TECHNICAL BULLETIN

[Issue No.] FA-A-0212

[Title] Change in the 40-pin connectors of MELSEC-L series modules

[Relevant Models] LH42C4NT1P, LH42C4PT1P

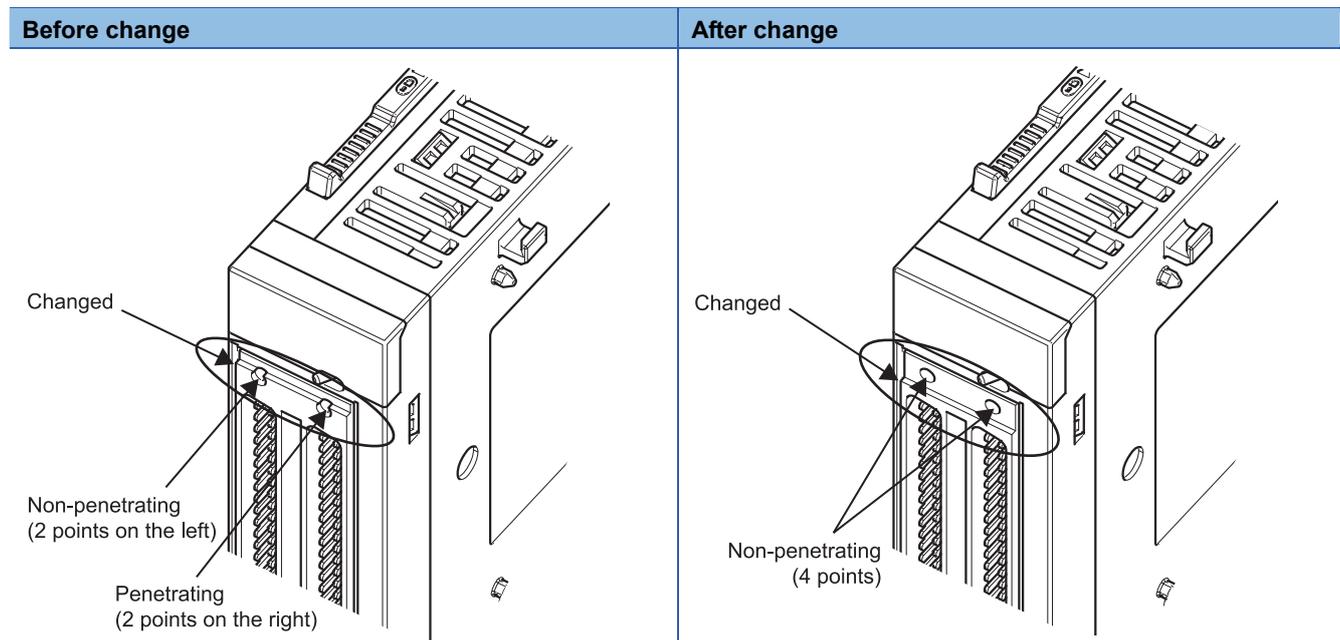
The 40-pin connectors of the above relevant models are changed.

The shape of the adjacent area of connector fixing screws is changed.
